### Dilley ISD Baseball and Softball Improvements Phase 2

#### ADDENDUM NO. 001

August 01, 2023

OVERALL SITE PLAN  
PHASE 2  
**SP2.0**

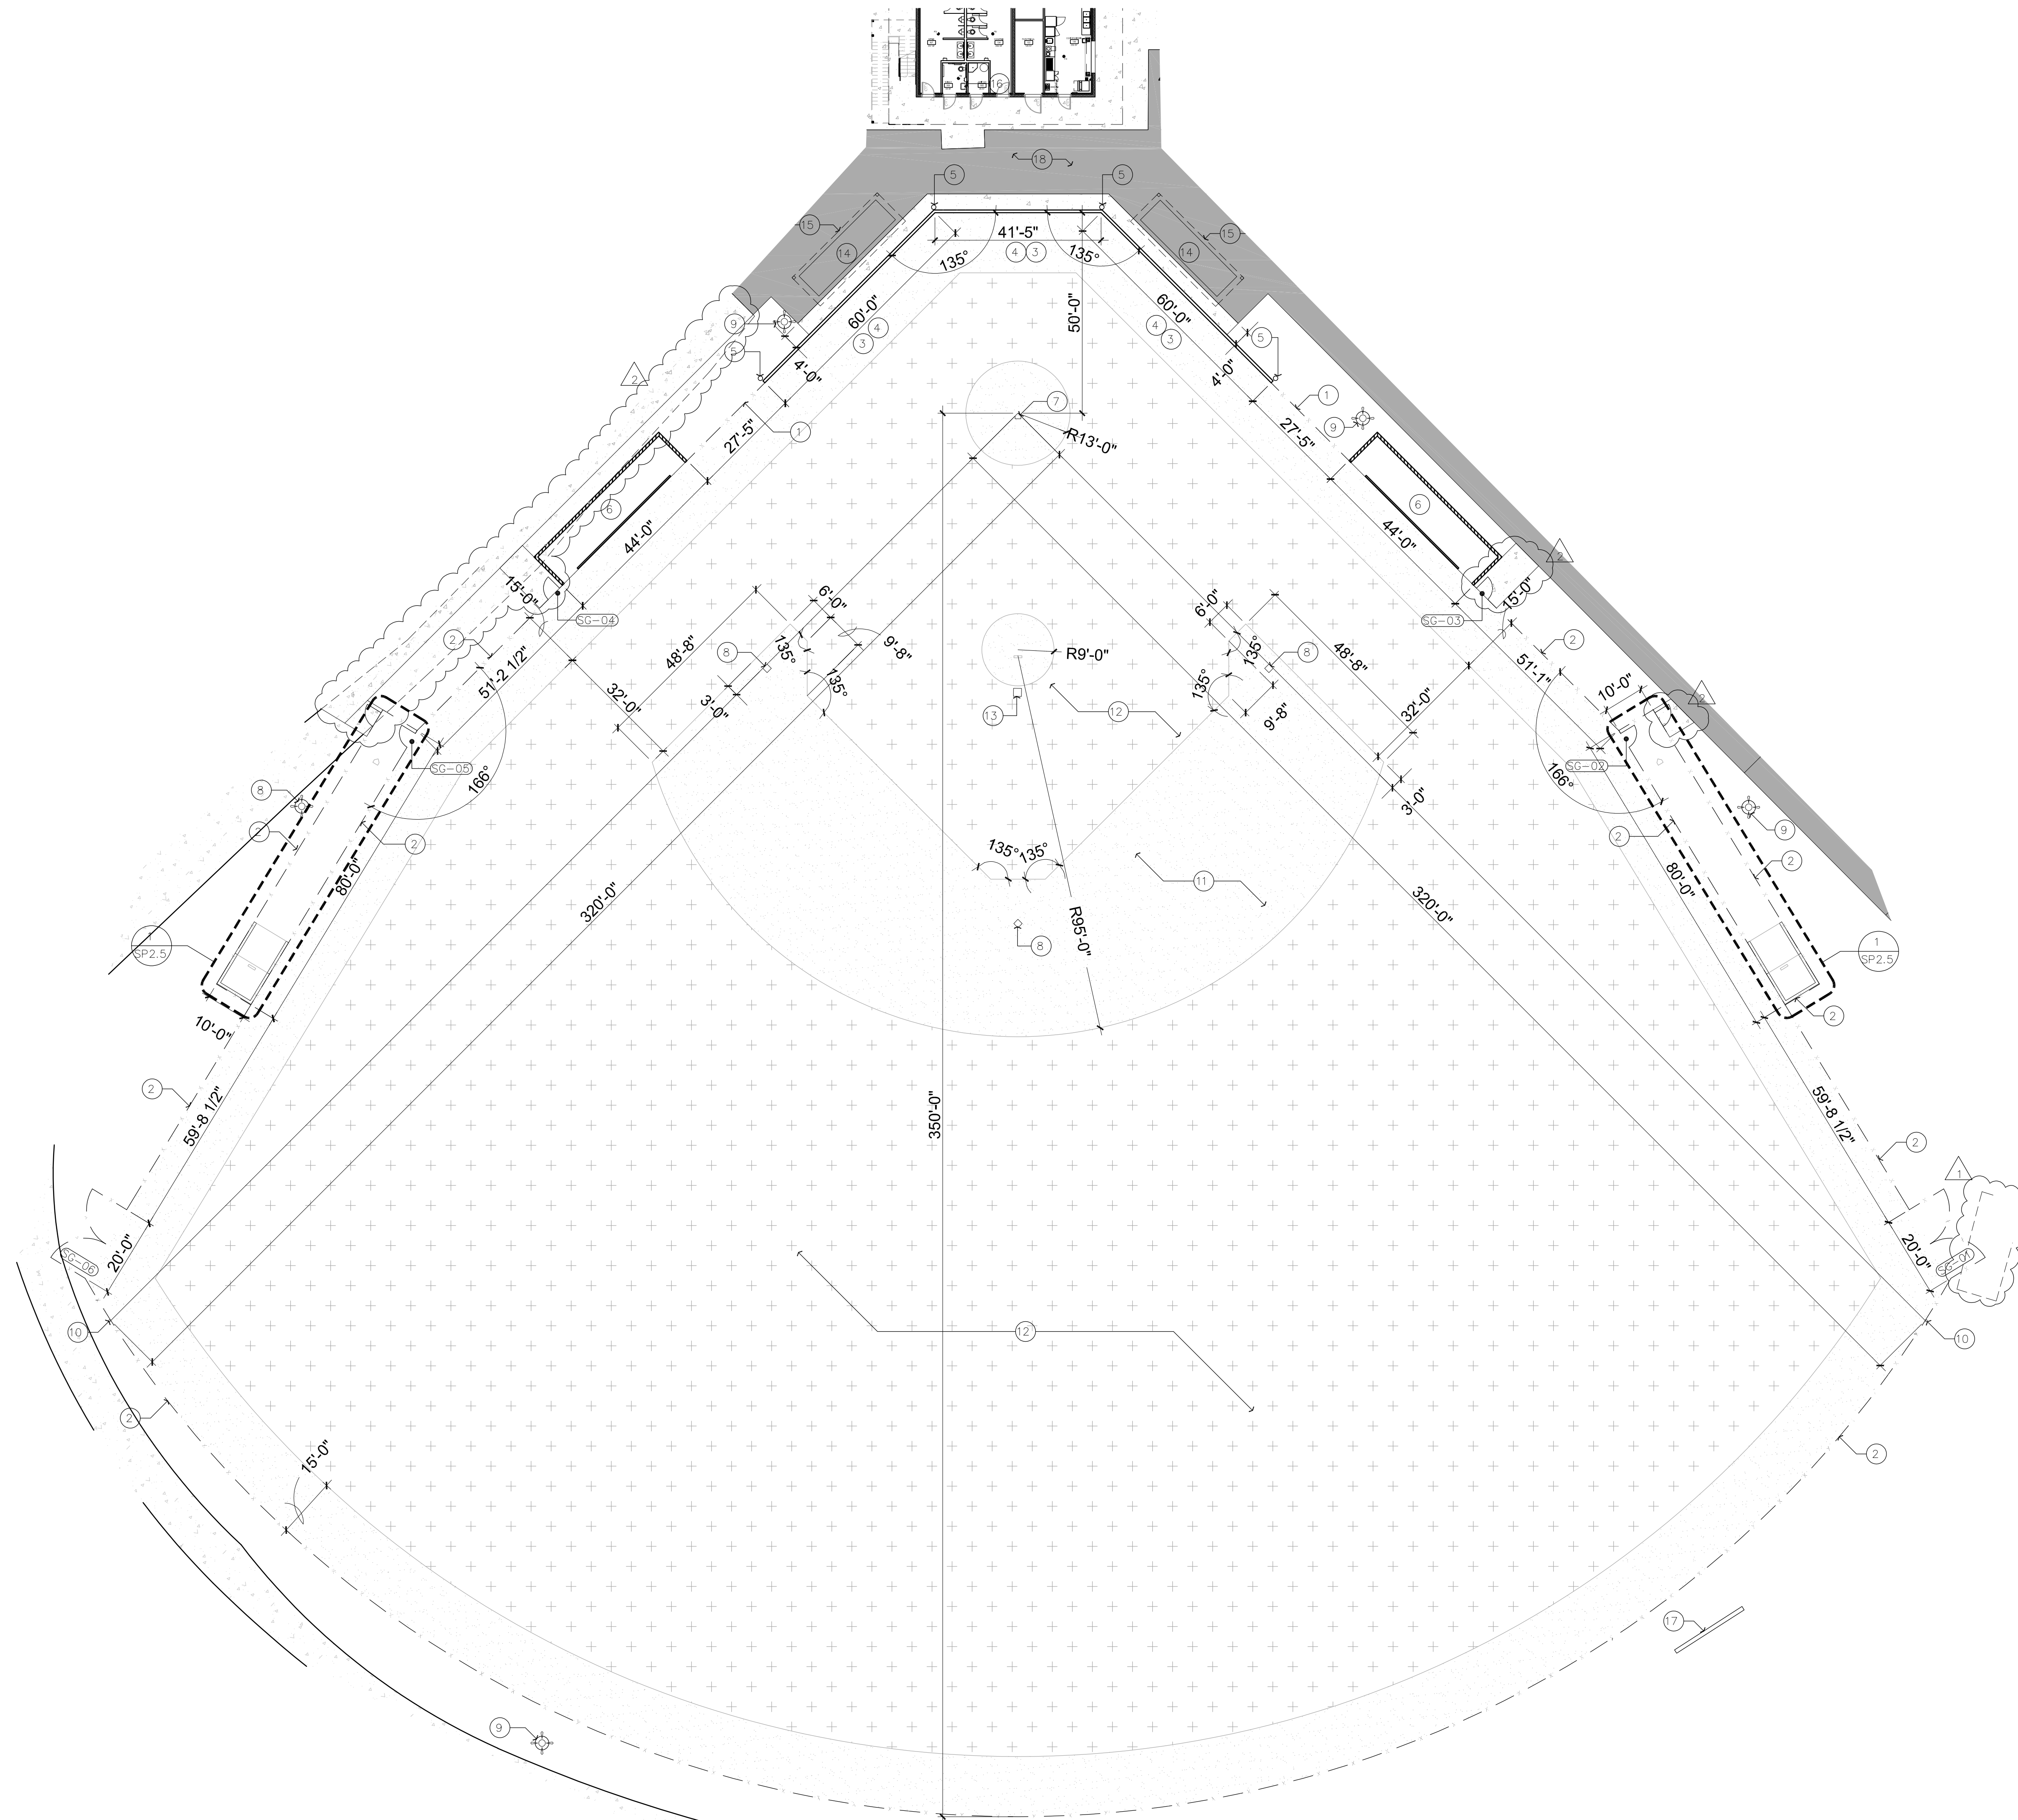
10. Furnish specifications of the wall pads and details of the custom graphics referenced in Keynotes #3, Sheet SP 2.1.
  - a. Wall pads to be equal to Beacon Woodless Backstop Pads, Graphics to be coordinated with client during construction.**

DETAILS  
SP2.5

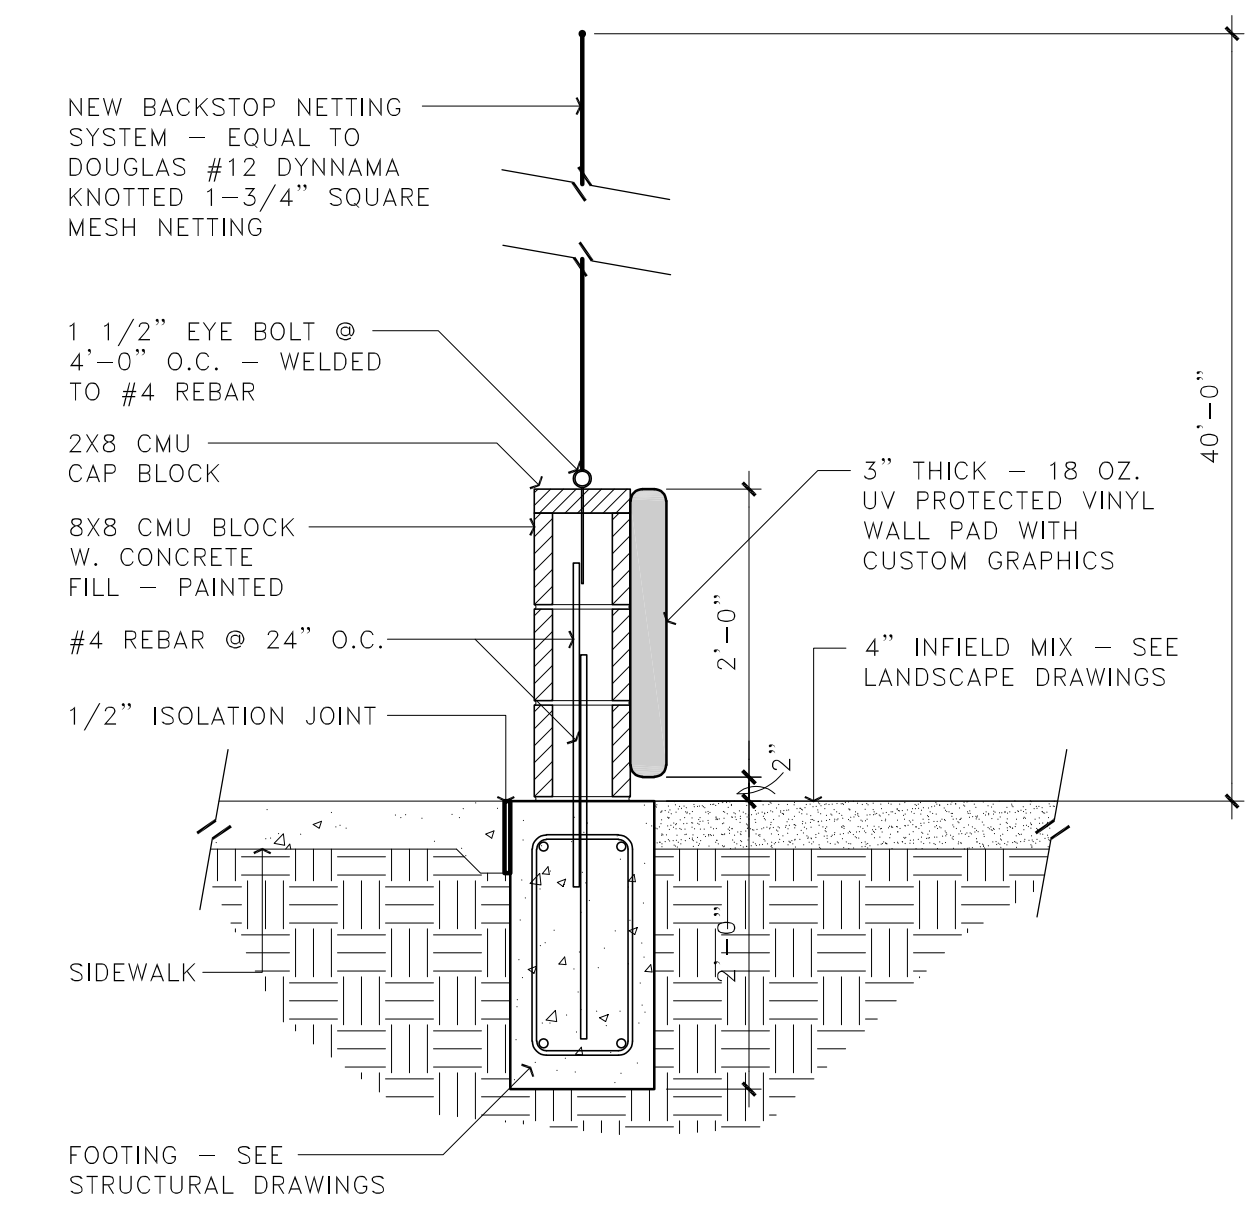
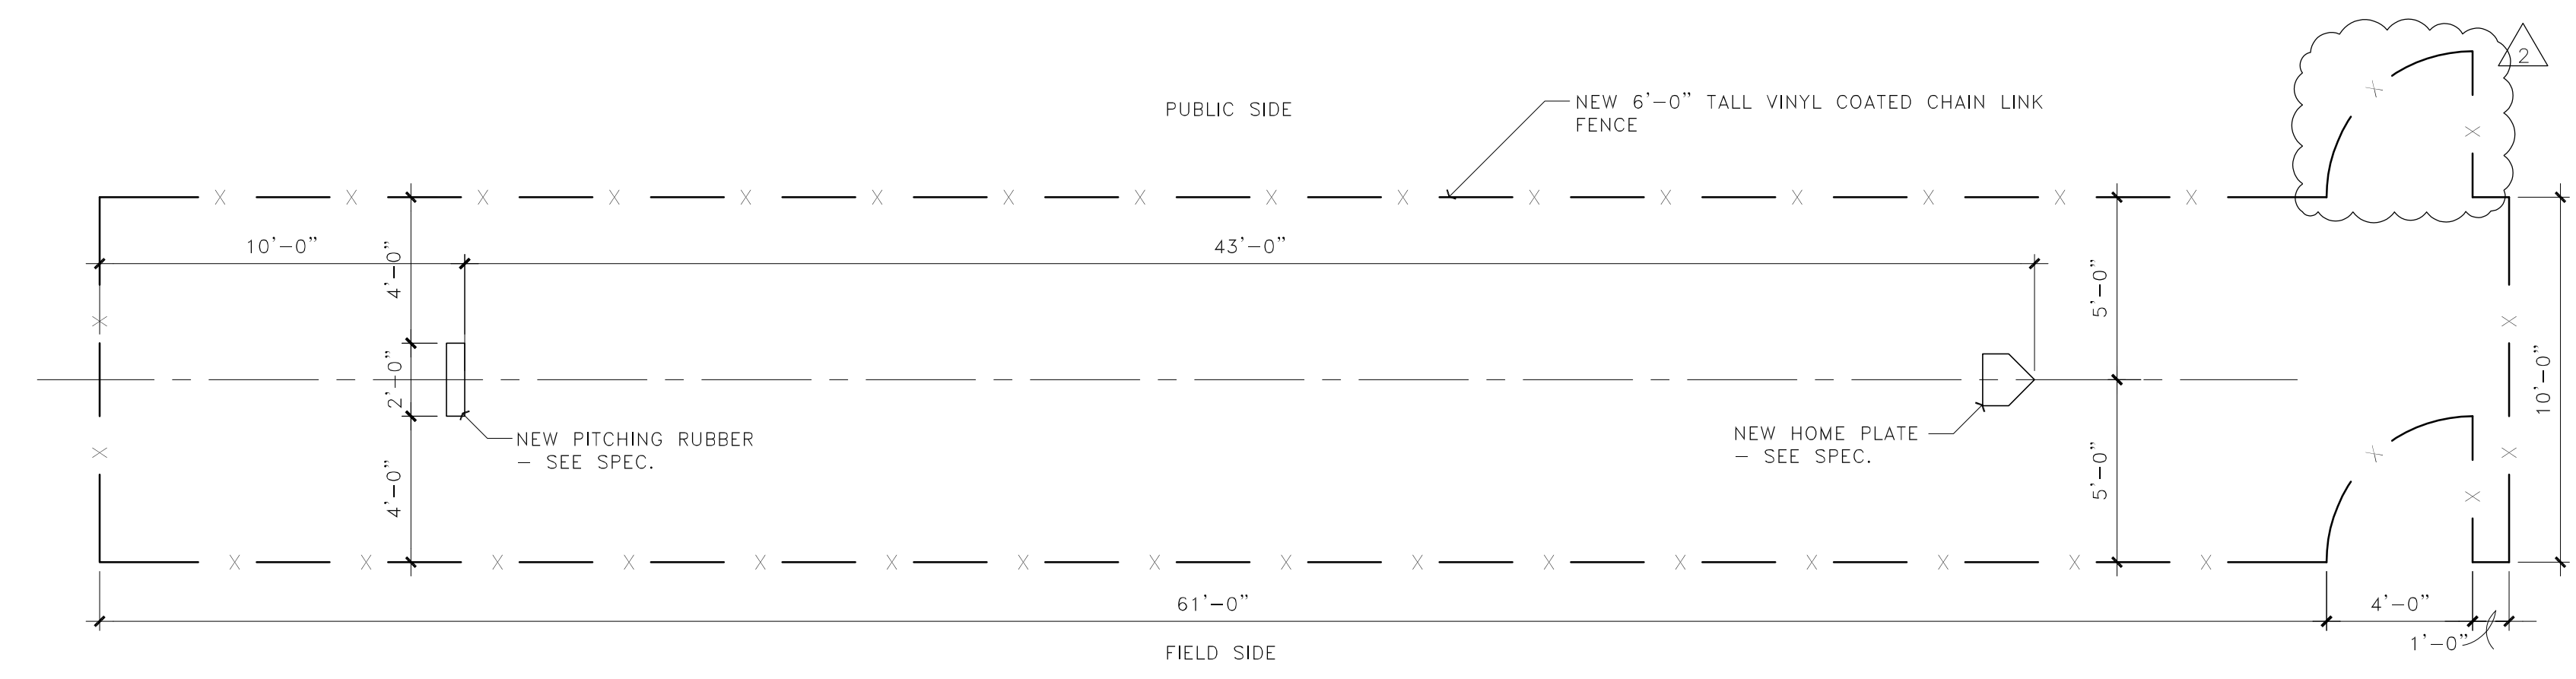
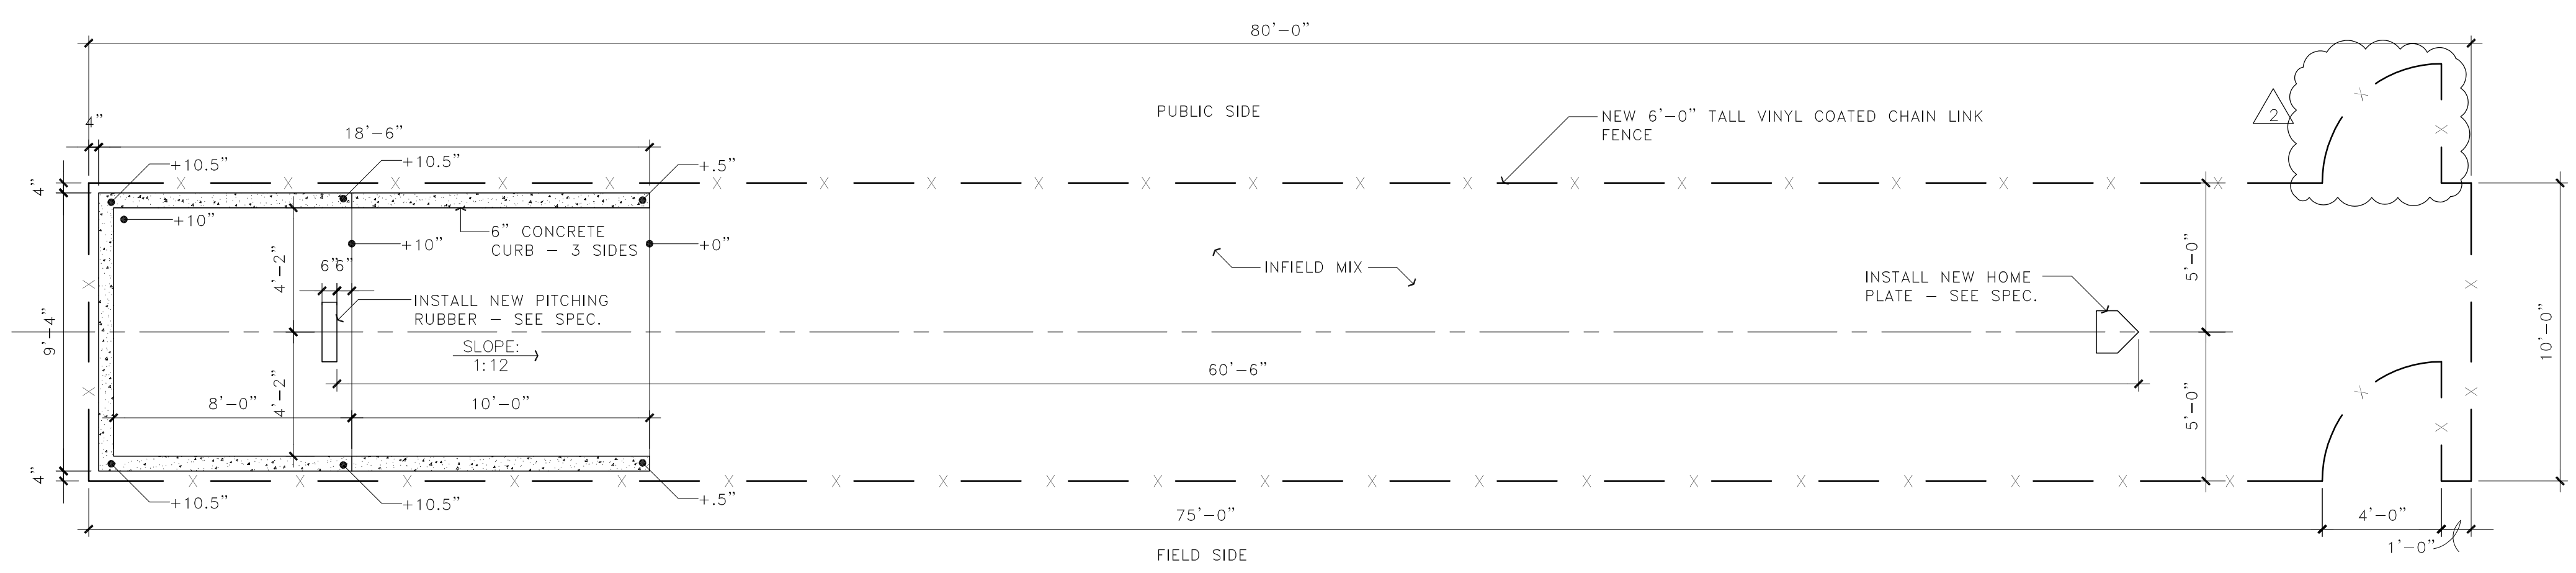
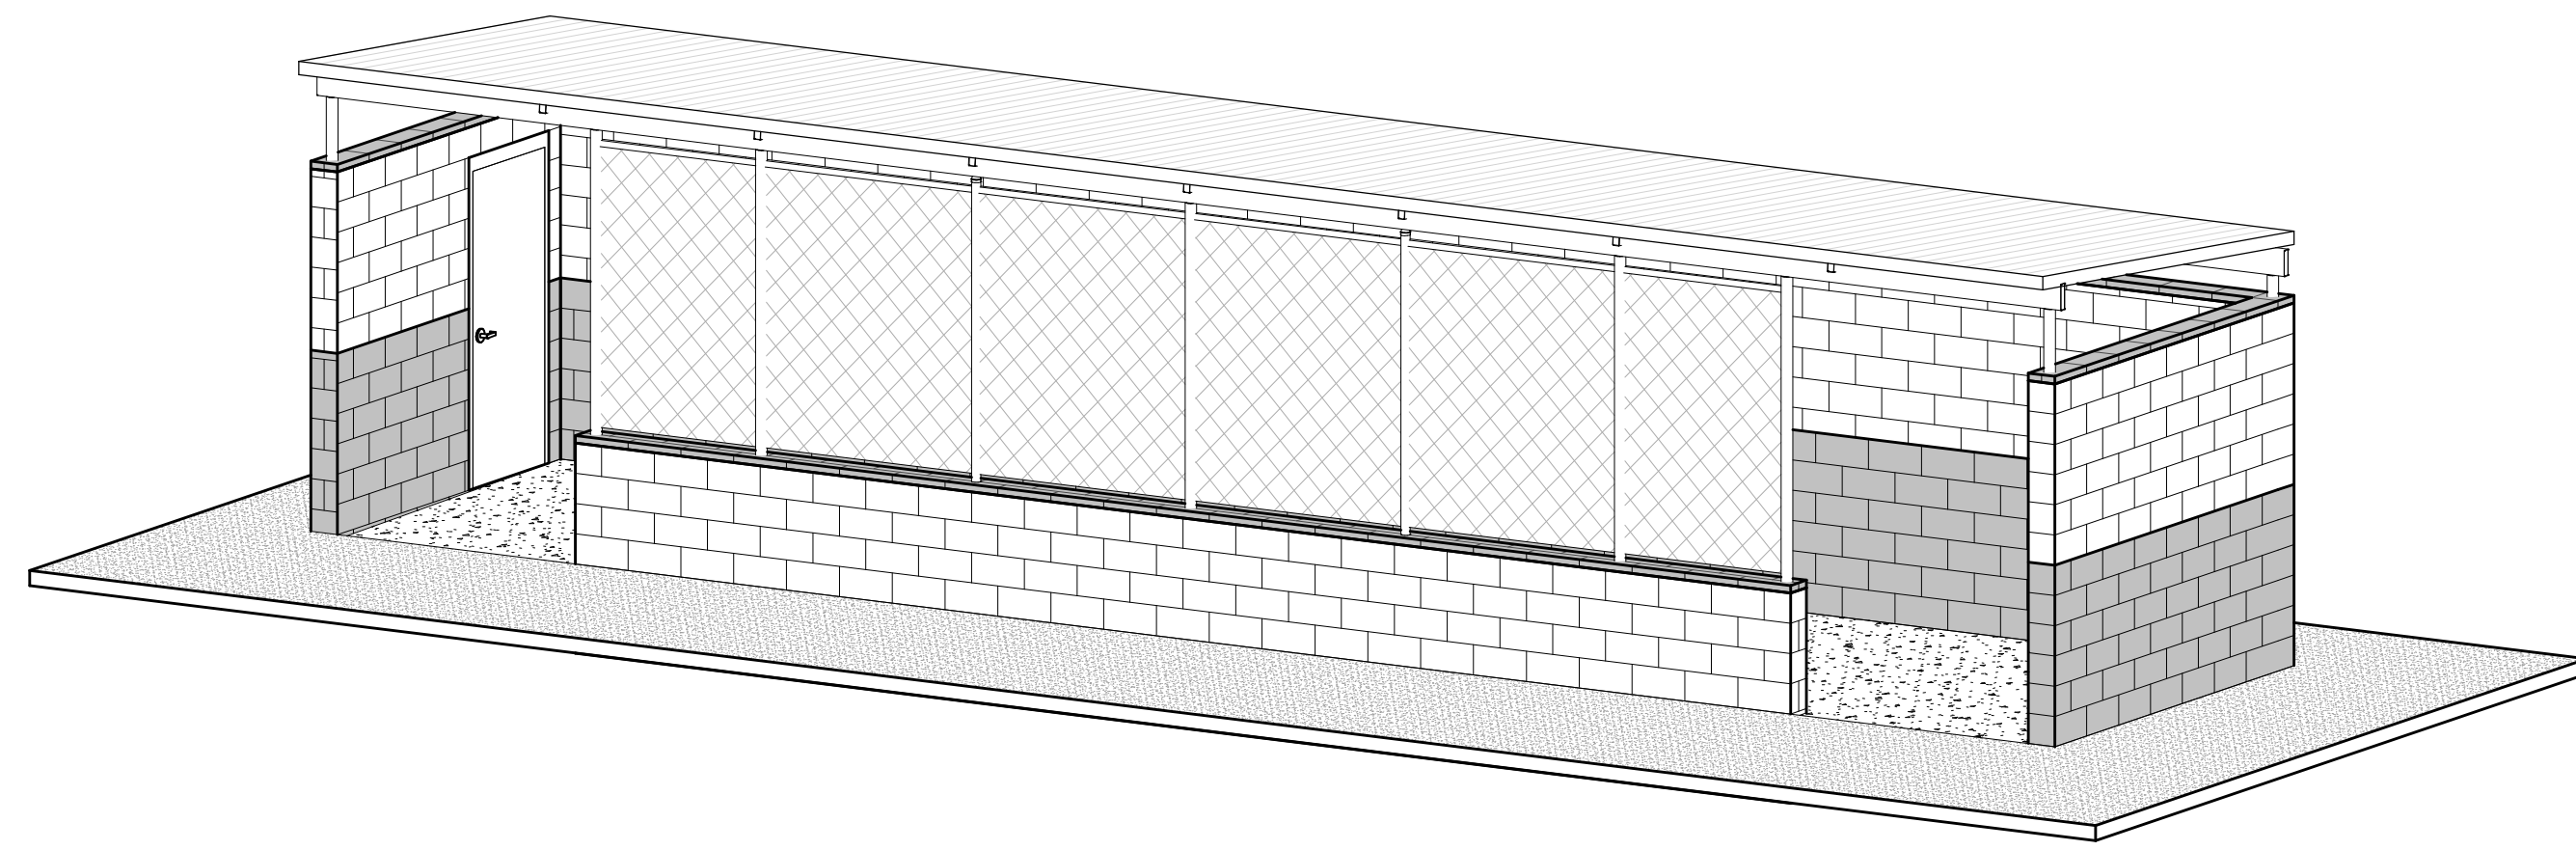
- a. 4" concrete on 2" sand base.**
9. Provide specifications for home plates and pitching rubbers as shown on Sheet SP2.5
  - a. Existing bases, home plate and pitching rubbers are to be reused and stay in place.**
